solo® AIRCRAFT ENGINES GMBH Industriestrasse 9 D-71069 Sindelfingen	Service Bulletin E.237 – 3 Electric Propulsion system 8000 Series	EASA.AP.136 Seite 1 von 9
--	--	---

Engine type: Solo 8000 / 400 and Solo 8000 / 401

Subject: Propulsion reliability affected by EMI Problems, due to connection issues of grounding

Fig. 1: Motor Controller

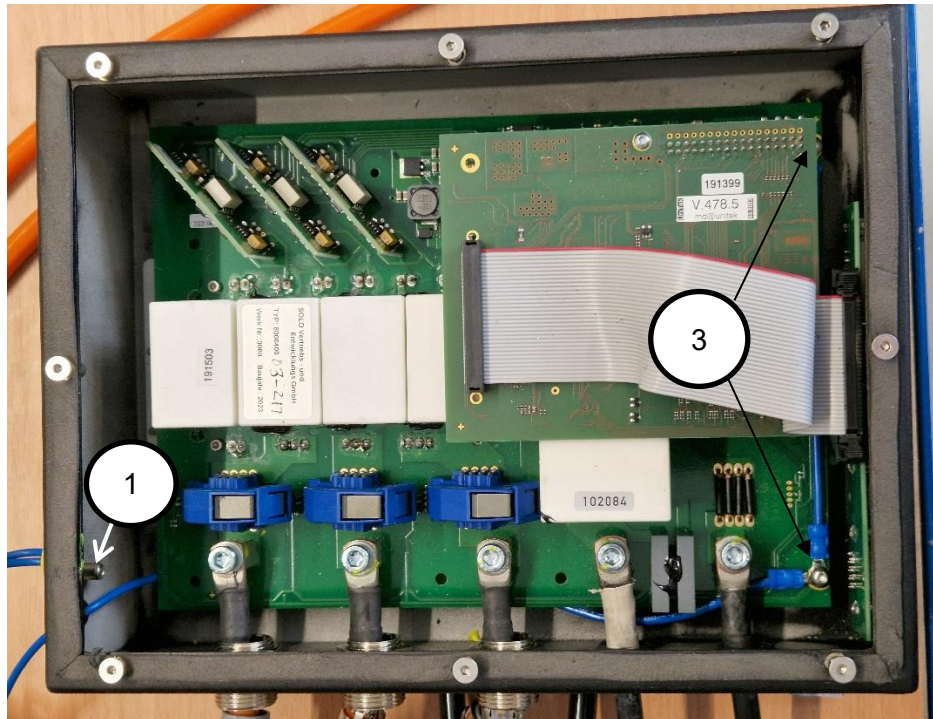
Action 3: Check for grounding at the resolver cable connector and the motor controller housing between Position 1 and Position 2.

- Action 4:** In case of a Motor Controller (MC) Power Fault, check the continuity between the screws at Position 3 in Figure 1: Motor Controller and Position 1. The resistance must be less than 0,2 Ω .

If no grounding is detected, remove the hex stud, remove any kind of corrosion or painting underneath to ensure proper electrical contact.

Fig. 3: SOLO housing with studs

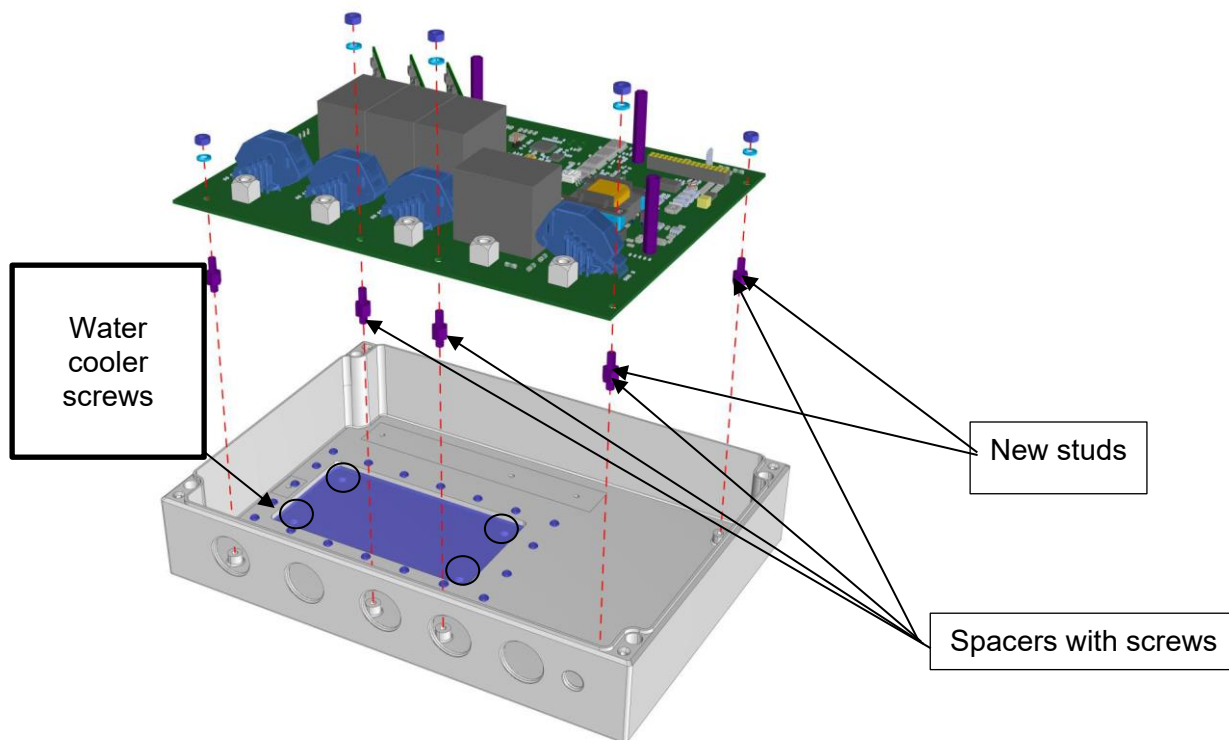
- If a SOLO housing is installed, replace 2 studs between the controller board and the controller housing, refer to Fig. 3
 - Perform the steps above in reverse order to assemble the controller again

Fig 4: EMI Spikes at the test bench

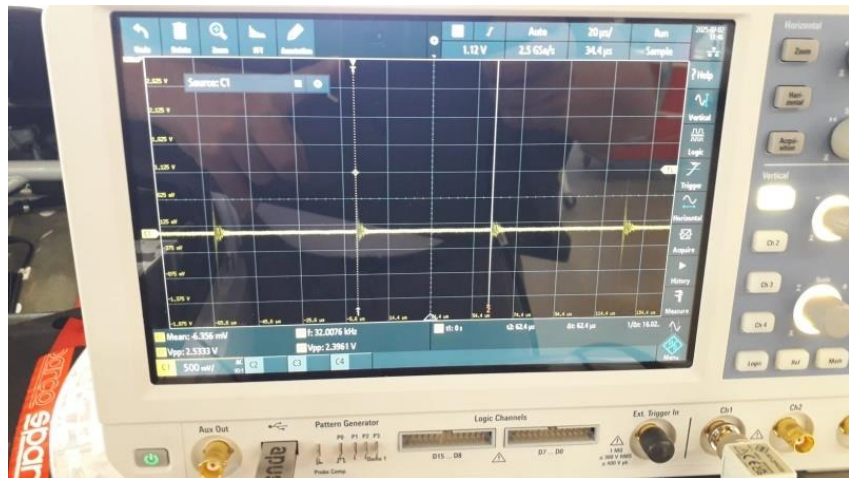
An acceptable result is the presence of a consistent less than +/-10 V peak-to-peak ripple (spike) at a frequency of approximately 16 kHz superimposed on the 12V DC line. This waveform is expected and aligns with the intentional design parameters of the system. Refer to Fig 4 and Fig 5. In case the specification can not be met, or any problems arise, Solo is to be contacted for verification.
